# WSDOT SR520 PROGRAM Pontoon Construction Project Expert Panel Report, Phase 2

Submitted to WSDOT by the Expert Panel February 18<sup>th</sup> 2013

Figure 1, Crack Maps for Pontoon V

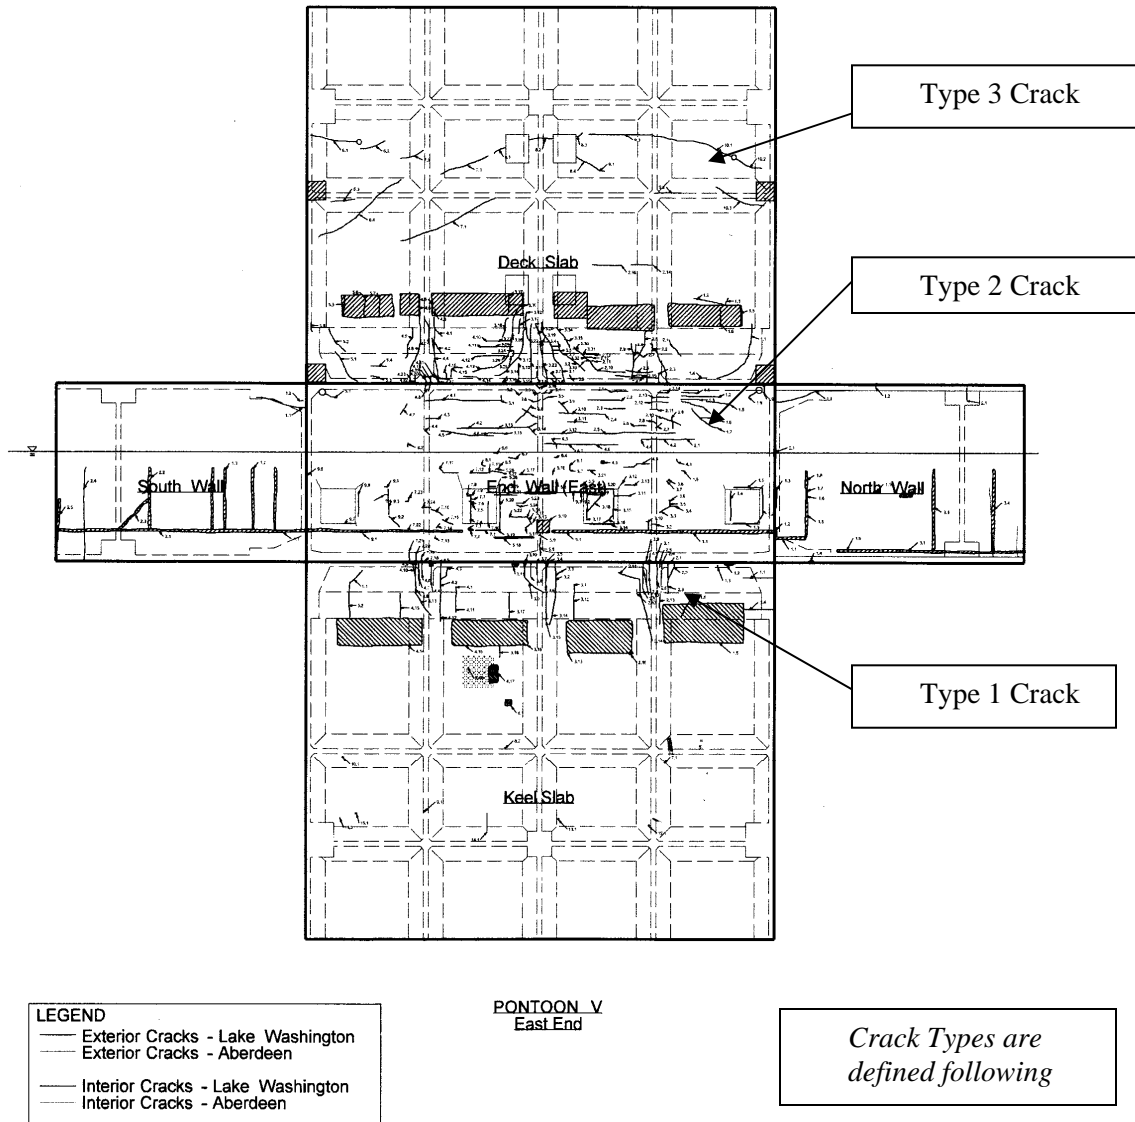
Shown in the figure below is a composite developed scale drawing of the cracking extent on the east end of cycle 1 Pontoon V. Both interior and exterior crack locations are noted. Where concrete was removed to permit the insertion of PT deviation reinforcement, and then replaced, it is indicated by hatching. The central portion of the diagram is the east end wall and the line of the top of the bolt-beam is clearly indicated by hatching.. To each side of that diagram and on the same horizontal line are diagrams for the adjoining east ends of the north and south longitudinal walls. Above the central diagram is the diagram for the adjoining east end of the deck slab and below is the diagram for the adjoining east end of the keel slab. The different cracks are identified as either Type 1, Type 2, and Type 3 cracks.

1. Keel Slab Cracks: (Crack Type 1 in figure). The most serious cracks are keel slab cracks that extend in the longitudinal direction of the pontoon. Similar longitudinal cracks are located sometimes in the exterior walls and frequently in the deck slab of the pontoon. Watertightness is of less concern for those wall and deck slab cracks than the corresponding keel slab cracks. The effects of the longitudinal post-tensioning are the same for all these cracks. Longitudinal cracks may be present due to the spalling stresses between tendon groups, bursting stresses in front of a tendon anchorage, and “shear lag” effects associated with the flow of prestressing forces into the precast interior walls . These cracks would be exacerbated by hydraulic loads in both service and extreme loading conditions.

2. End Wall Cracks, pontoons A & W: (Crack Type 2 in figure). There is no bolt-beam inside the end walls for these two pontoons (the bolt-beams are located in the middle of the side walls). Existing cracks in the body of the wall will be exacerbated by both service and extreme hydraulic loads. They will have withstood the hydraulic loads associated with towing which may have further opened and/or extended existing cracks. These walls are only subject to hydraulic loads perpendicular to the plane of the wall in service. It should be a relatively simple task to estimate crack width under service and extreme loads and carry out appropriate repairs.

3. End Wall Cracks, pontoons T through V (Crack Type 2 in figure) Existing cracks in the body of the wall inside the bolt-beam will be exacerbated by both service and extreme hydraulic loading conditions. pontoons T, U, and V have withstood the hydraulic loads associated with towing which may have further opened and/or extended the existing cracks. Once the pontoons are connected these end walls are no longer subject to load except for the pressure due to grouting of the joints. The panel does not believe that these end wall cracks are likely to be a major cause for concern for regarding service life and maintenance.

4. Longitudinal Wall and Deck Slab Transverse Cracks (Crack Type 3 in figure): These cracks should close upon application of the longitudinal post-tensioning. The only question pertains to the width under extreme loads and the potential leakage amounts. The BSO estimation of the potential crack widths, due to longitudinal flexure of the pontoons, was based on a strain compatibility analysis. The results from such an analysis were compared with the service and extreme moment demands. Shear cracking due to torsion and vertical shear was predicted and is coincident with flexural demands. The effect of the longitudinal prestress in limiting such cracks and on the resulting slope of the cracks was neglected. This is conservative.
